**BEFORE THE HEARING EXAMINER
CITY OF SEATTLE**

Hearing Examiner File: MUP-18-001
Department Reference: 3028431

APPELLANT'S RESPONSE TO
APPLICANT'S MOTION TO DISMISS

Figure 4- From Page 5 of the Applicant's Motion, Item A

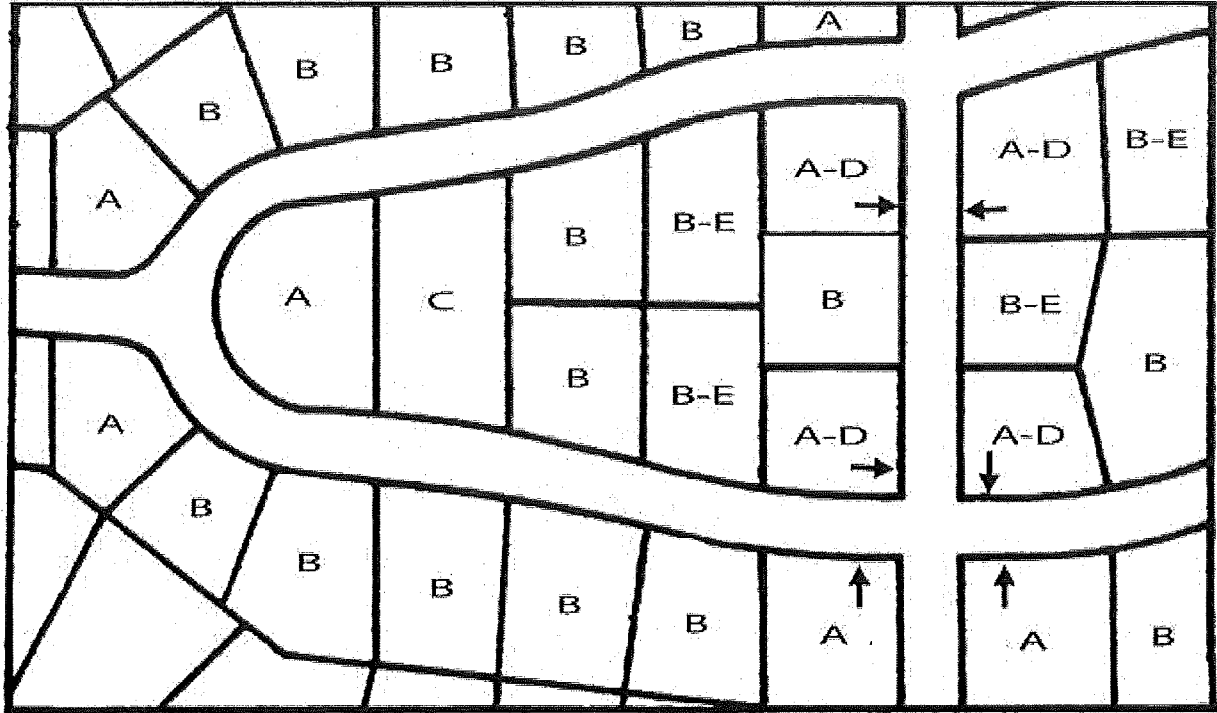
Item A04 – issue raised (see Figure 4 above): Short Plat fails to provide exclusive access for each of the two lots and comply with minimum lot requirements.

According to SMC 23.84A.001 - Applicability and interpretation, part A, states "The definitions in this chapter provide the meanings of terms used in this title, except as otherwise provided by this title or as the context may otherwise clearly require." The definitions established within section 23.84A applies to all of Title 23. As such, the Applicant's suggested interpretation that the Land-Use code definitions are not a requirement of the short plat is not a valid statement.

In order to have a legitimate lot from the short plat subdivision, vehicular access has been identified as a requirement in several applicable areas of the land-use code. The first example is referenced by the Applicant as Exhibit A of SMC 23.88A.024 (see Figure 5 below). Graphically
